**Planning and Environment Committee Meeting No. 12/14**

<b>Item</b>		<b>Page</b>
1	CONFIRMATION OF MINUTES - Meeting held on 4 November 2014.....	1
2	21 GORDON STREET, EASTWOOD - LOT 10 SECTION 4 IN DP 7076. DA for a multi dwelling housing development with 4 units - 1 x 2- storey 5 bedroom dwelling at the front and 3 x single storey 3 bedroom dwellings at the rear. LDA2014/0089. <i>INTERVIEW 5.00PM</i> .....	5
3	7-9 RUTLEDGE STREET, EASTWOOD, LOT 1 DP1111051 and LOT 24 DP 653568. Staged Development: mixed use development comprising 613m2 of retail space and 100 residential apartments upon completion of both stages & strata subdivision. LDA 2011/0612.....	80

**Figure 3: Site Plan extract of the proposed development with each of the four (4) dwellings proposed highlighted in blue and labelled in red. The red perimeter represents the boundary of the subject site at 21 Gordon Street, Eastwood.**

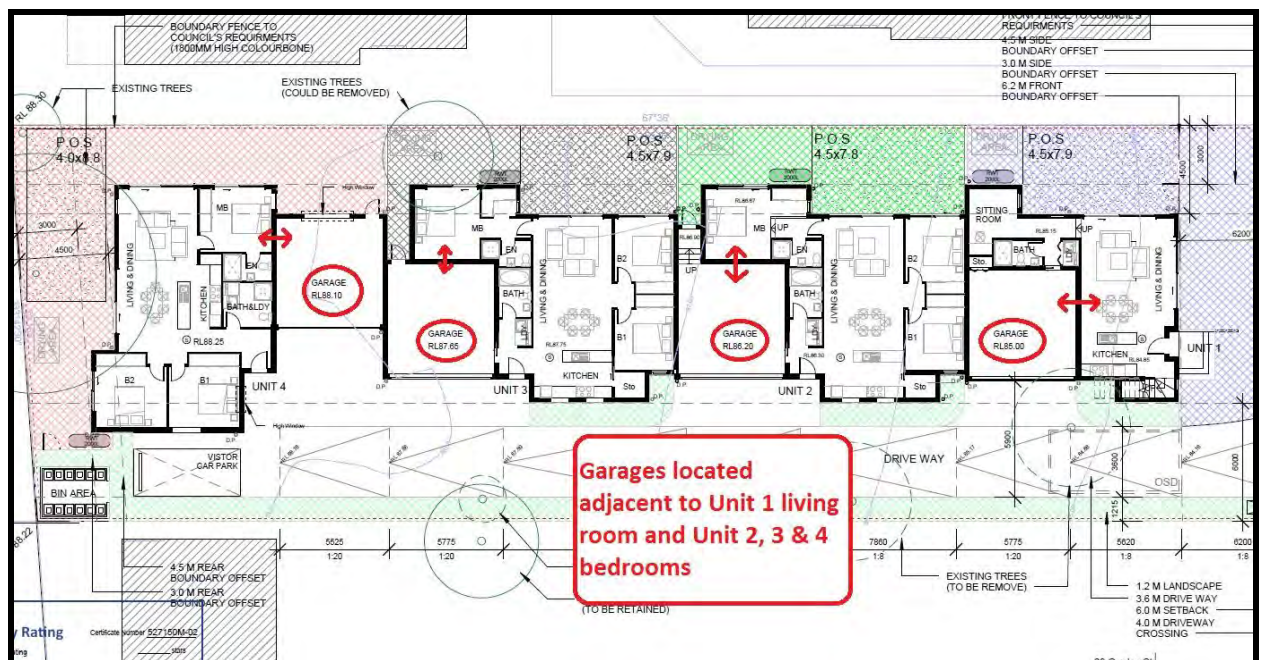
An assessment of the plans has revealed that each of the proposed garages will share a wall with either a living or sleeping area of an adjoining dwelling. (demonstrated in **Figure 21**). There is concern that this arrangement may give rise to have negative acoustic privacy implications for the future residents of the development.

**Garage walls.** Garage walls are to be lined with acoustically absorptive material or equivalent to that minimise the transmission of noise to the adjacent living and sleeping areas of the dwellings. Plans including details of the materials and their installation arrangements are to be prepared and submitted to the Principal Certifying Authority prior to the issue of the **Construction Certificate**.

**SOUTH ELEVATION - RUTLEDGE ST (Showing Level 10 Units deleted)**

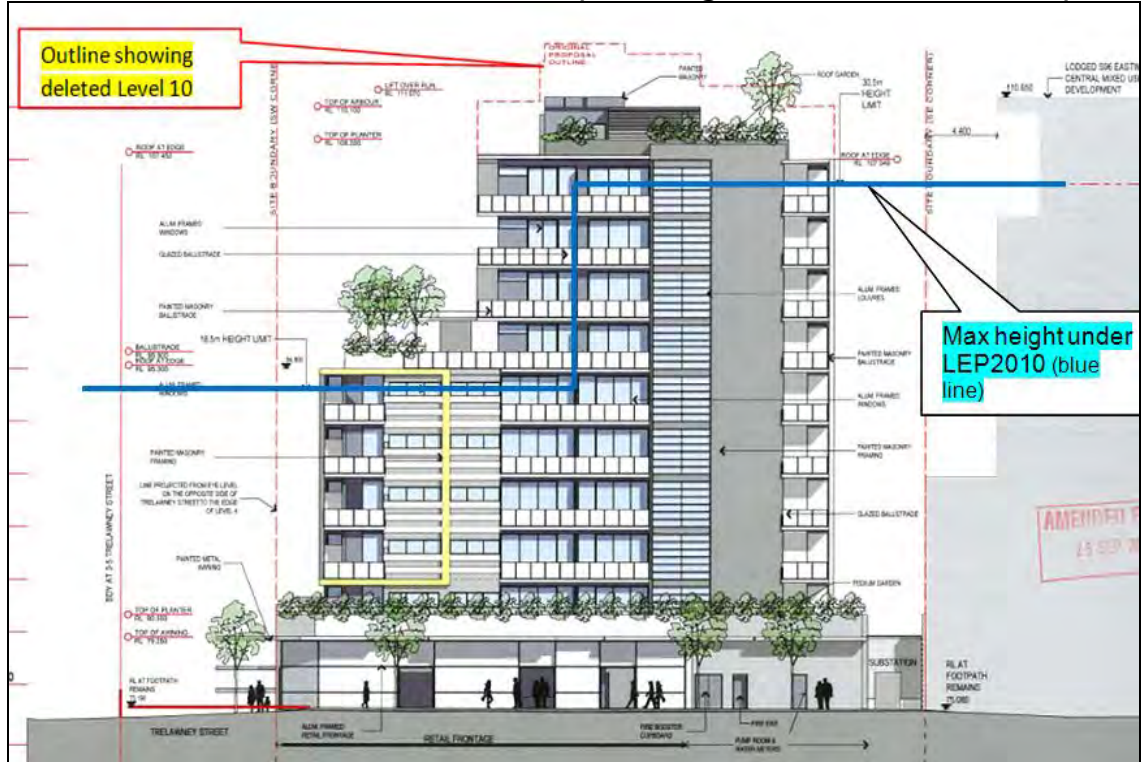
The above plans confirm that the requirement (as per Council Resolution) to delete the top level of the building has been achieved.

**STAGE 1:  
AMENDED PLAN SHOWING PROPOSED ACCESS FROM TRELAWNEY STREET**

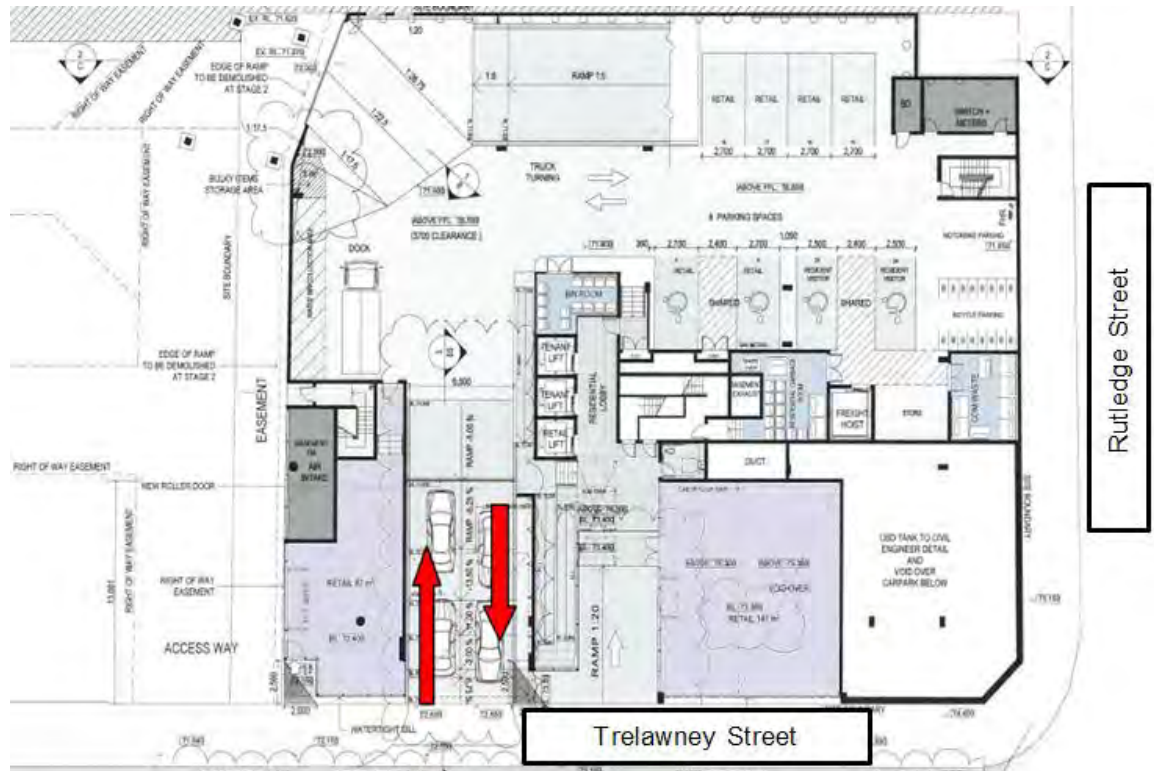
The amended proposal received on 16 September 2014 proposes vehicular access directly off Trelawney Street in the manner shown in the plan below.

The above access arrangement (new access directly off Trelawney Street) has been reviewed by the RMS and Council’s Traffic Team and Senior Development Engineer and is considered satisfactory.

**STAGE 2:  
AMENDED PLAN SHOWING ALTERNATIVE ACCESS FROM ADJACENT  
ROW**

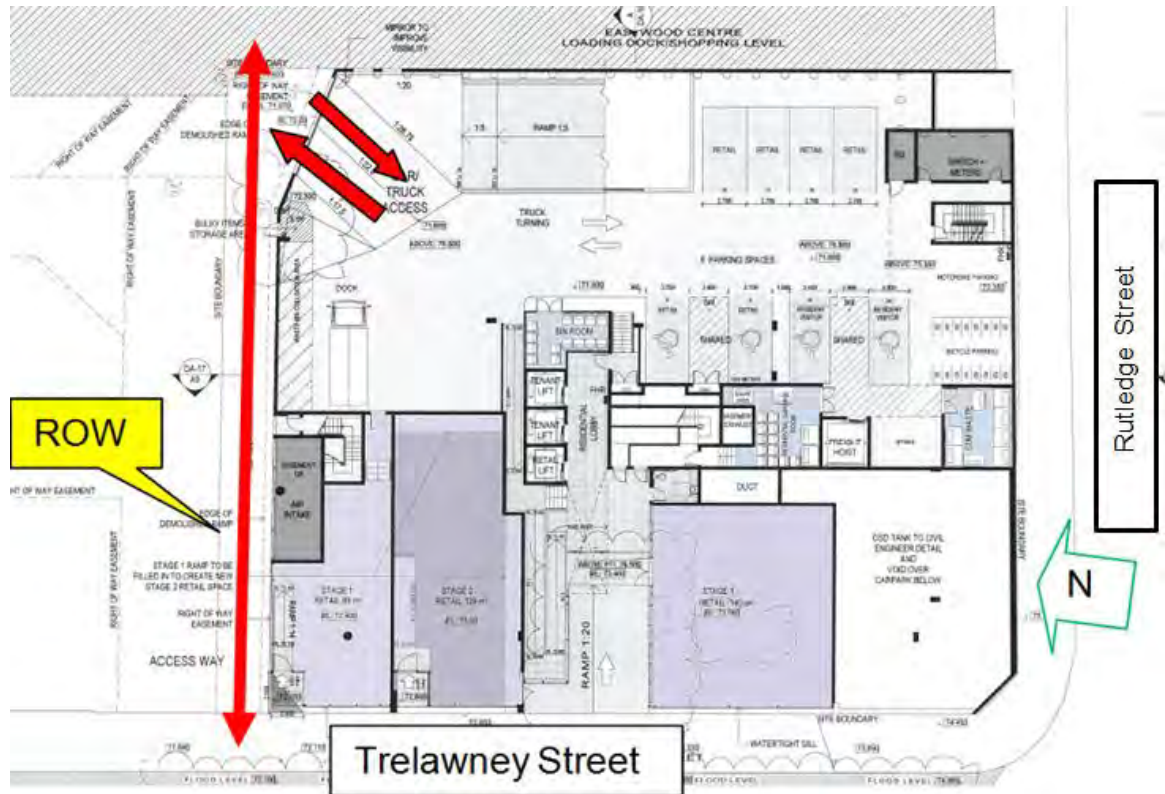
The above plan shows Stage 2 of the proposal for which concept approval is sought. Should the alternative access be available in the future, a further approval will be required by the applicant to change to the new access arrangement as shown under Stage 2 Consent plan. Should the current DA be approved, appropriate conditions have been recommended to allow staged development to accommodate the transition to new access and conversion of approved access ramp into retail space. These matters have been included in the conditions to ensure that no works under Stage 2 is carried out without further assessment of access arrangement via a new DA (see Condition No.127).
